RAI Volume 2, Chapter 2.1.1.4, Eighth Set, Number 4:

RAI Volume 2, Chapter 2.1.1.4, Eighth Set, Number 8:

RAI: 2.2.1.1.4-8-008

Figure 1. Aging Pad 17P Partial Plan and Section Showing Cut Slopes, Northeast Corner

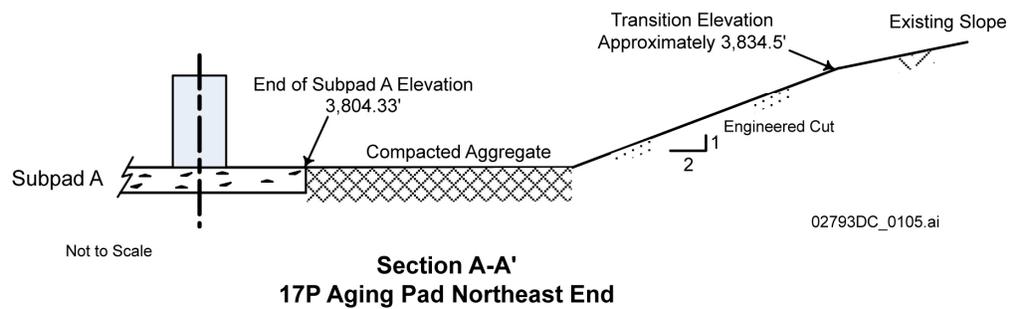
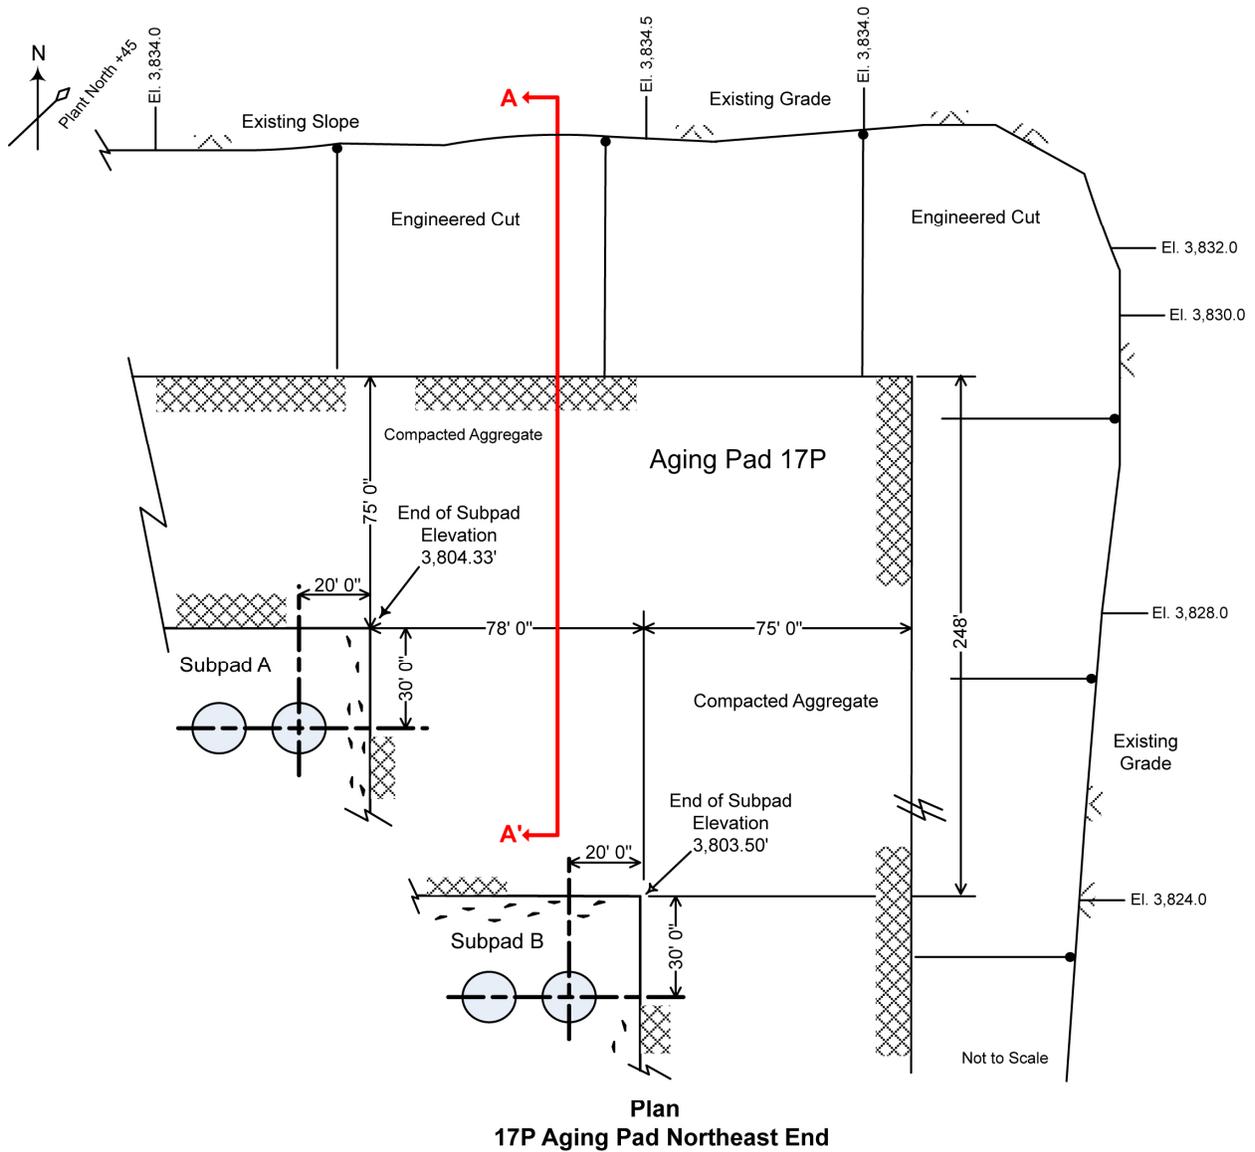
Provide an analysis of potential event sequences related to failure of cut or fill slopes near the aging pads or on transportation routes to and from the aging pads, or explain how these event sequences will be prevented or mitigated.

SAR Figure 1.1-129 and information on the terraced layout of the aging pads in DOE's response to a previous RAI (RAI: 2.2.1.1.7-3-001) on this subject suggests that excavation and fill for aging pad foundations could expose the alluvium in cut and fill slopes of up to approximately 9 to 10 m [29 to 32 ft] high. Failure of the cut slope could result in the failed material depositing on the Aging Facility located in the vicinity of the toe of the slope. This material could block the vents of the Aging casks and potentially impact the Aging cask complying with the thermal limit requirement for the fuel being aged at the facility. Failure of a fill slope, where the Aging facility is located on top of the slope, has the potential for the Aging Casks to be in the failure zone and be unstable. Also, transportation routes that link the aging pads to other surface-facility structures (SAR figure 1.2.7-2) could involve cut or fill slopes. DOE has not provided an assessment of the stability of the slopes for static and applicable seismic loading conditions and did not identify potential event sequences resulting from failure of the slopes. This information is needed to determine compliance with 10 CFR 63.21(c)(5) and 63.112(b).

The *Geologic Repository Operations Area Aging Pad Site Plan* (BSC 2008a) shows the general layout of the aging pads, the relative proximity of the aging pads to the various surface facilities of the repository, security fencing surrounding the aging facility, access roads, and the designation for each of the two aging pads (17P and 17R). The aging pad site plan also provides the topography and preliminary cut and fill information for the aging facility slopes. Further perspective on the topography and preliminary cut and fill information are shown on Figures 1, 2, and 3.

The compacted aggregate aging pad periphery typically extends 75 ft. beyond the concrete mat, such that vertical aging cask would be no closer than 89 ft to the upslope hillside from the toe of the engineered cut that will be no steeper than 2H:1V. As shown in Figure 1, a slope failure of an engineered slope 29 to 32 ft high would not result in soil sliding onto the aging pads and contacting an aging cask. The distance of the aging pads and vertical aging casks from up-slope hillsides precludes soil from sliding onto the concrete aging pads and contacting the aging casks (BSC 2007a, p. A-4). The layouts for aging pads 17P and 17R also illustrate that the engineered design recognizes and mitigates the potential failure of cut and fill slopes. The highest engineered slope (approximately 32 ft) is located in the northeast corner of aging pad 17P (BSC 2008a and Figures 1 and 2).
